WICHITA - SEDGWICK COUNTY

Re: S/D 82-70 - Preliminary plat of Edwards Whitchurch Village
Addition

Preliminary plat
SUBDIVISION REPORT

S/D No. 82-70 Name Edwards Whitchurch Village Addition
Date Application Rec'd. 12-10-82 Preliminary Approval _____
Scheduled S/D Meeting 12-23-82

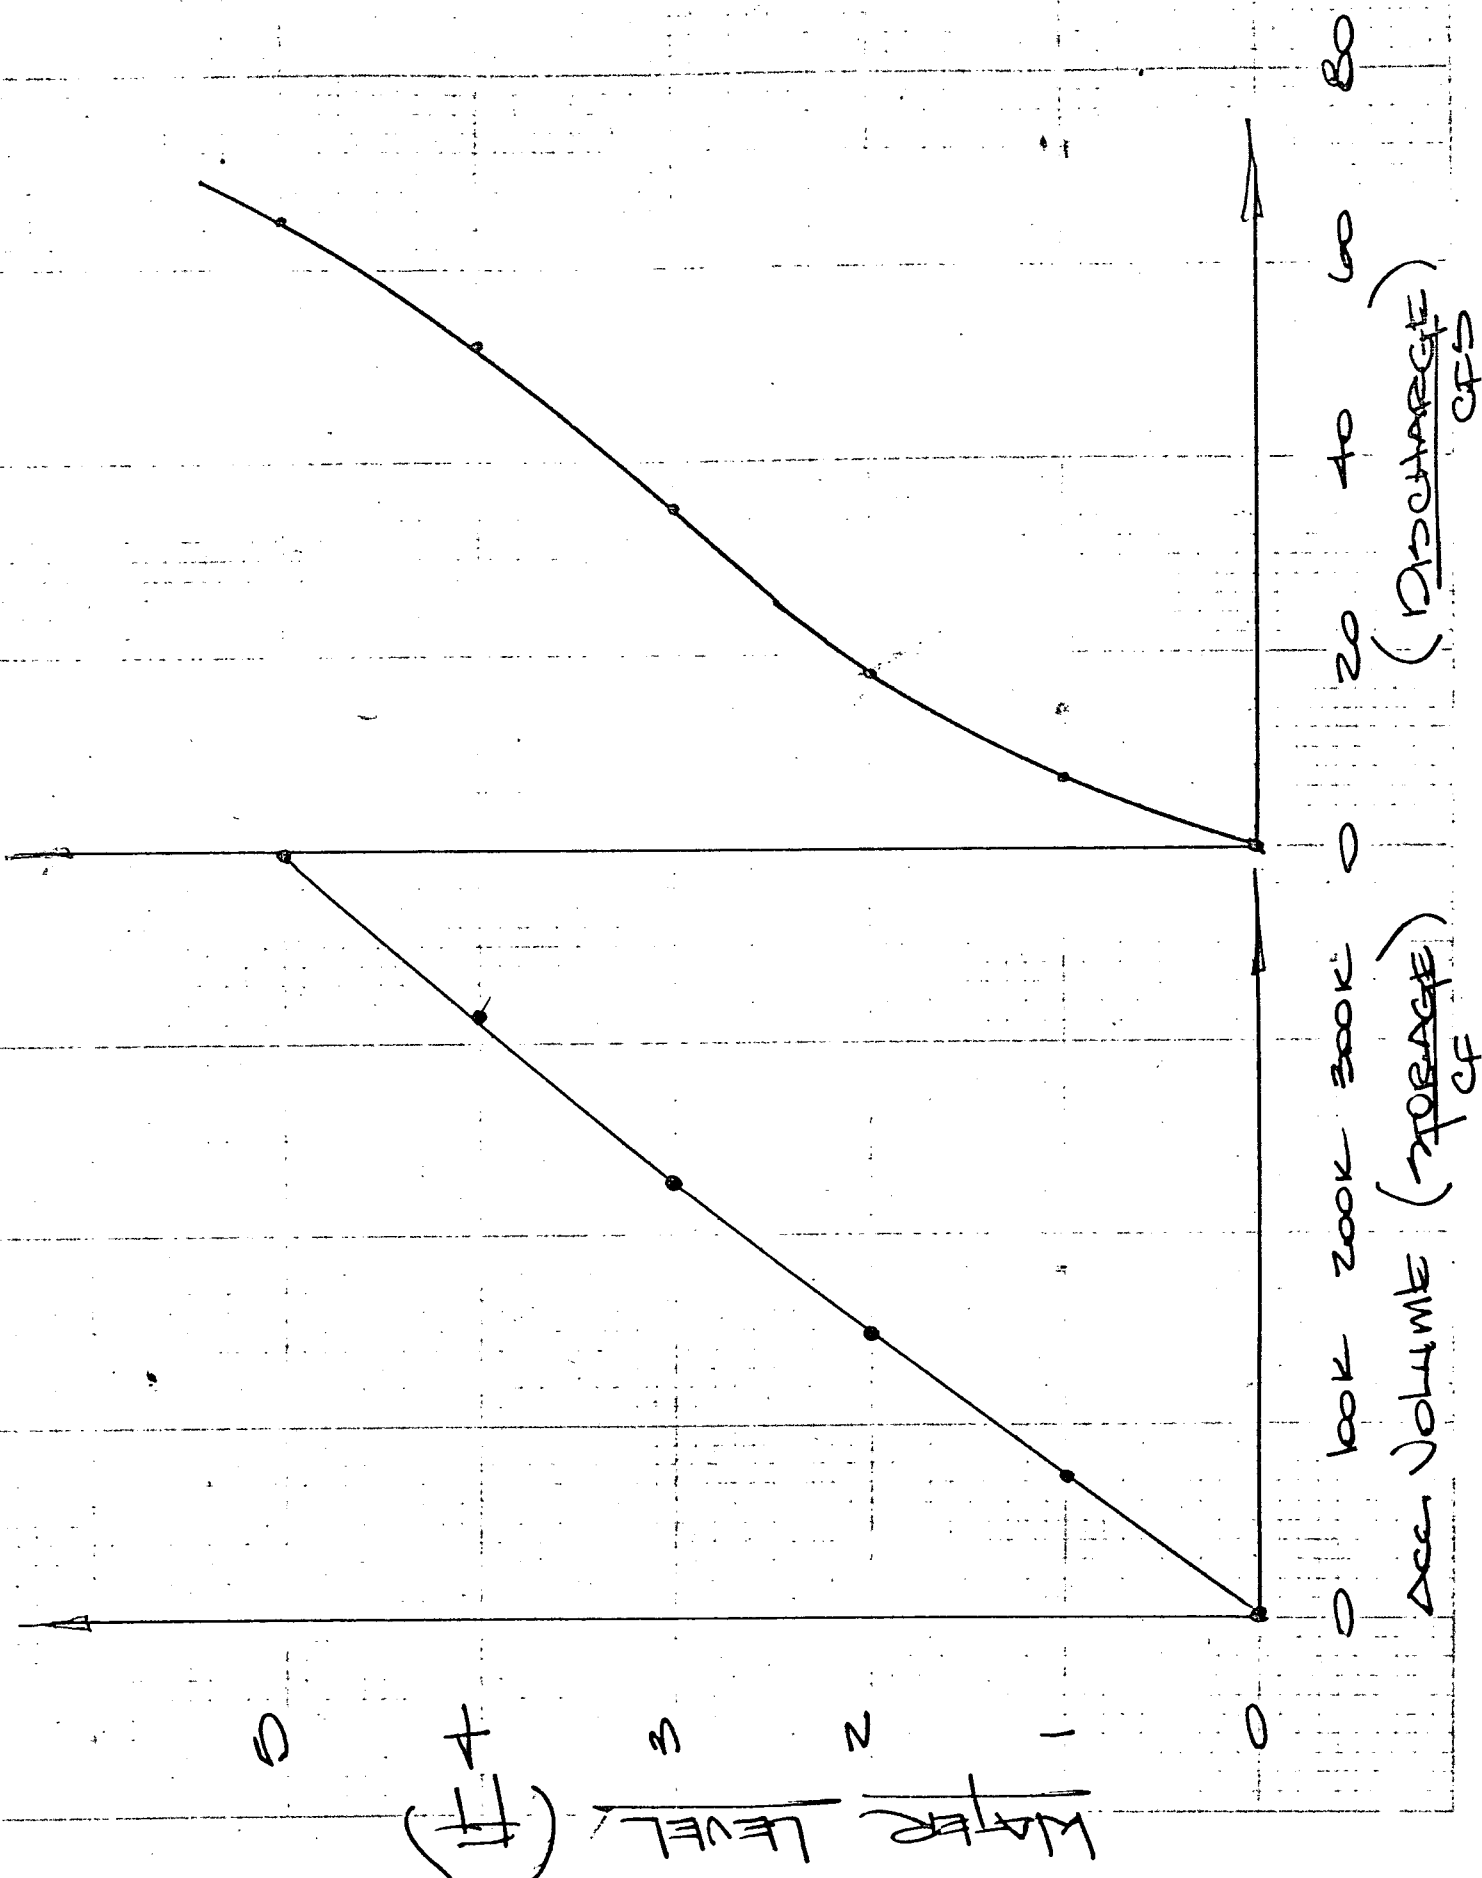
t/t_p	q/Q_p	t	Q
0	0	0	0
0.1	0.015	2.5	1.5
0.2	0.075	5.0	7.5
0.4	0.28	10.0	28.0
0.6	0.60	15	60.0
0.8	0.89	20	89.0
1.0	1.00	25	100.0
1.2	0.92	30	92.0
1.4	0.75	35	75.0
1.6	0.56	40	56.0
1.8	0.42	45	42.0
2.0	0.32	50	32.0
2.4	0.18	60	18.0
2.8	0.09	70	9.0
3.0	0.07	75	7.0

Plot the co-ordinates.

INFLOW OUTFLOW
HYDROGRAPH

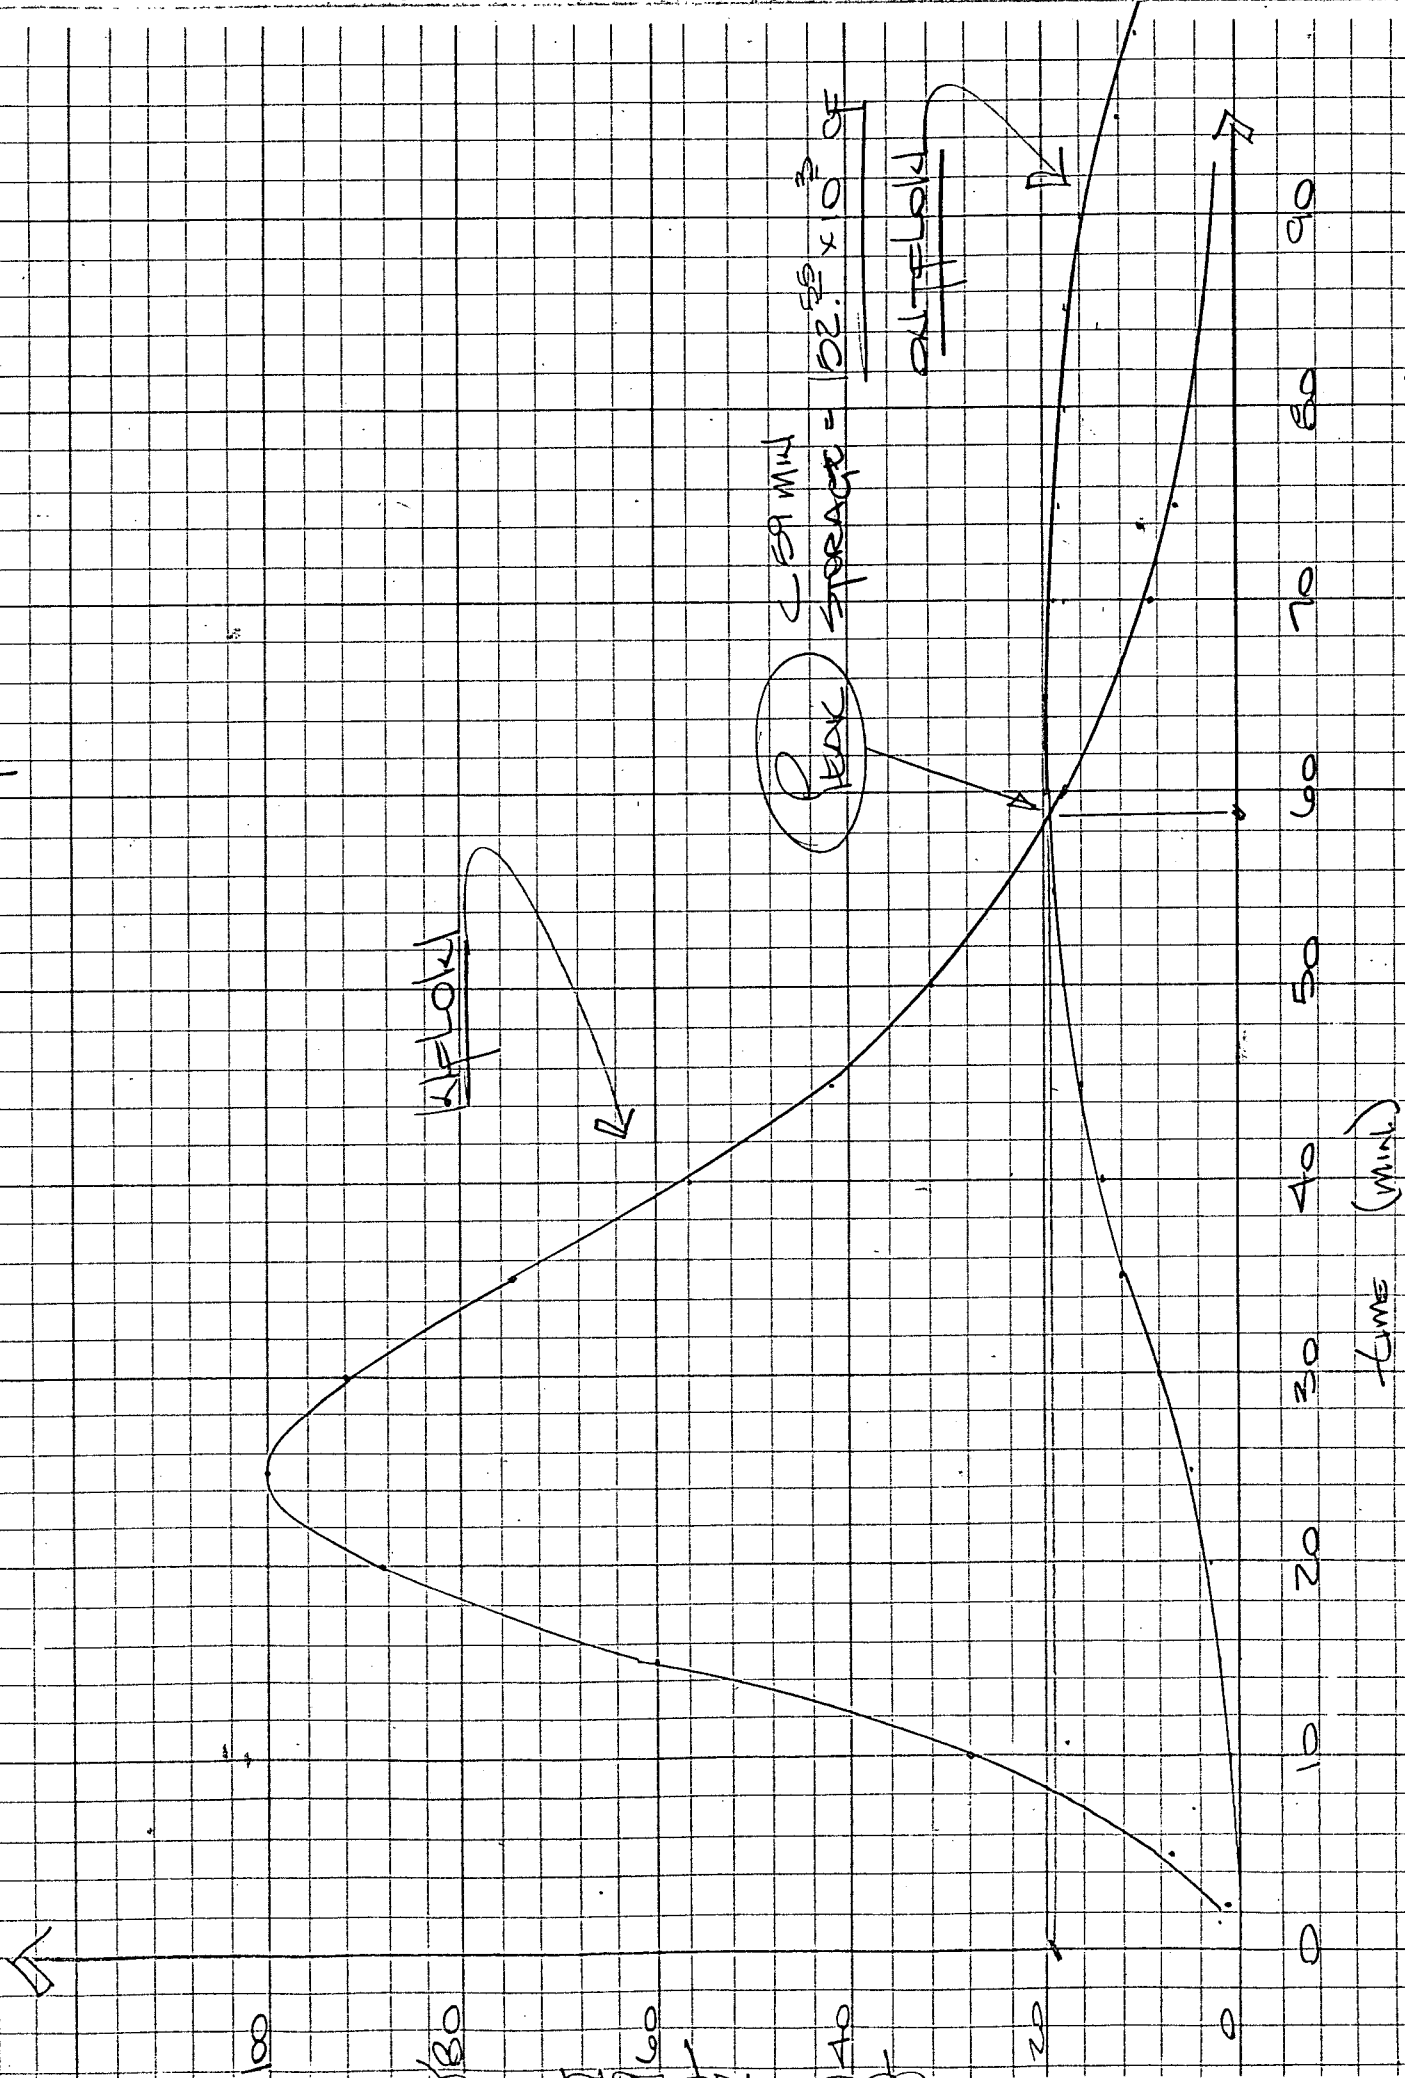
Results - FROM THE ROUTED FORM THEN THE
36" CWP, STORAGE NECESSARY
= 152,550 CF OR 3⁵ AC-FT.

PROPOSED POND PROVIDES FOR
APPROXIMATELY 9⁰ AC-FT. OF STORAGE,
SO THE POND BOTTOM WILL PROBABLY
BE RAISED AT LEAST A FOOT OR SO
SINCE THERE IS A SURPLUS OF STORAGE
AVAILABLE. A FINAL HYDROGRAPH AND
SIZING OF POND AREA WILL BE PRESENTED
IN THE FINAL PLAN FORM.
